STATE BUILDING CODE COUNCIL

Testing requirements per ASHRAE 62.2 for combination inlet/outlet

Code(s) **WSMC** **Section(s)** **401.4**

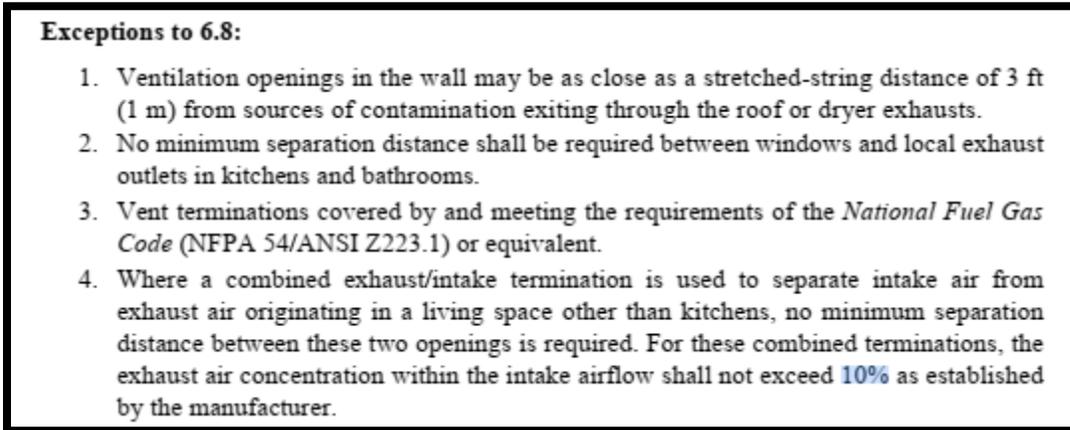
See proposed a new section **401.4** below in **red**, to align with Seattle Mechanical code.

3. Intake openings shall be located not less than 3 feet (914 mm) below contaminant sources where such sources are located within 10 feet (3048 mm) of the opening. Separation is not required between intake air openings, operable window openings, and living space exhaust air openings of an individual dwelling unit or sleeping unit where an approved factory-build intake/exhaust combination termination fitting is used to separate the air streams in accordance with the manufacturer's instruction. **For these combined terminations, the exhaust air concentration within the intake airflow shall not exceed 10% as established by the manufacturer, in accordance with ASHRAE 62.2 Section 6.8, Exception 4.**

This is just requiring items meet a specific testing requirement and helps to align with ASHRAE 62.2. Not typical to see differences in prices with equipment. Below is the clip from ASHRAE62.2
